PULLOUTS AND POCKET DOOR DETAILS

SOURCE COORDINATION / 22 OCT 2026

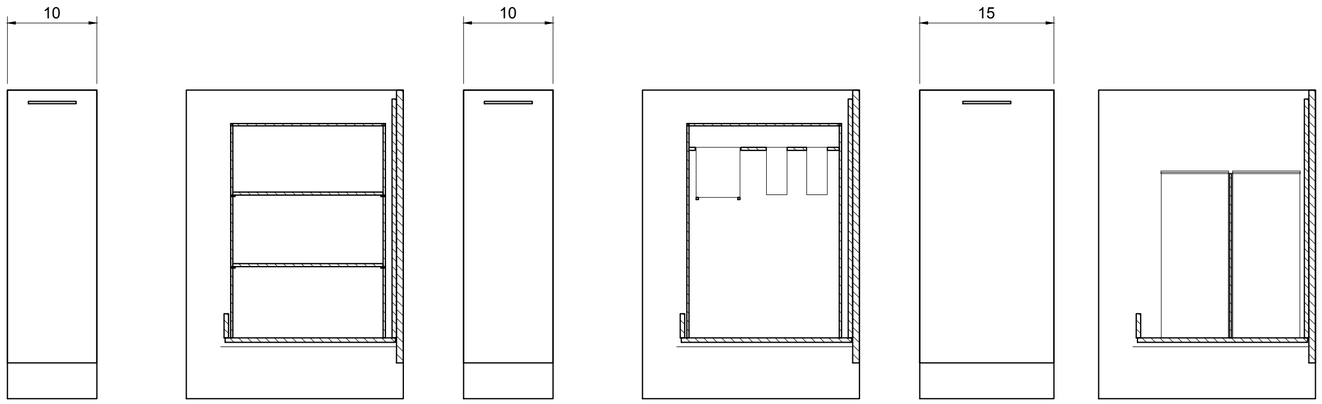
22 OCTOBER COORDINATION
Range pullouts: 10 in. bays.
Spice left / utensils right facing range.
Full-height fronts with top horizontal pulls.
Waste bay remains 15 in. wide.
Two tandem bins + divider/support.

INTERIORS ARE SCHEMATIC
Proposed fit coordinated with 3D study.
500 mm runner / final rating pending.
Bins: 10.9 W x 7.5 D x 18.5 H study.
Final capacities and supplier pending.
No fixed shelf / door hinges in pullouts.
Closed-front elevations on A201 / A202.

16 POCKET DOOR / INSIDE

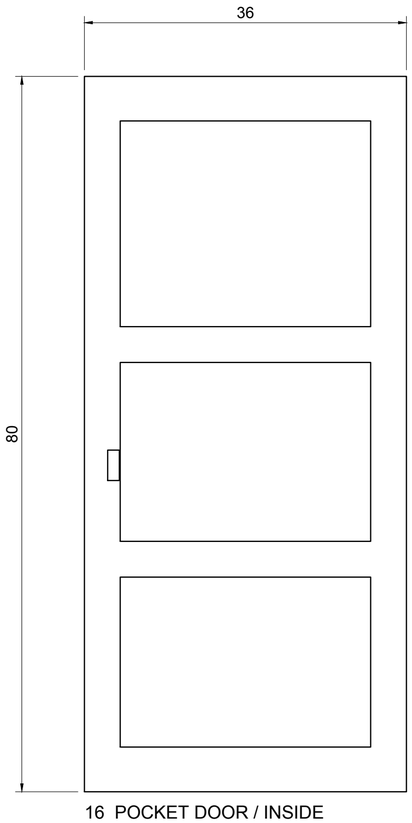
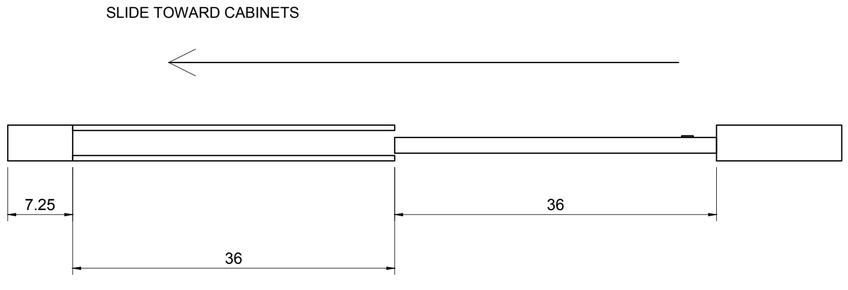
Pocket D120.25-156.25; opening D156.25-192.25.
7.25 from cabinet end D113 to pocket start.
Inside-left pull at D189; opening position retained.

POCKET DOOR
Handle left from inside kitchen.
Leaf slides right toward cabinet side.
36 x 80 opening position unchanged.
Pocket cavity between retained wall skins.
Kit, wall framing and services to verify.
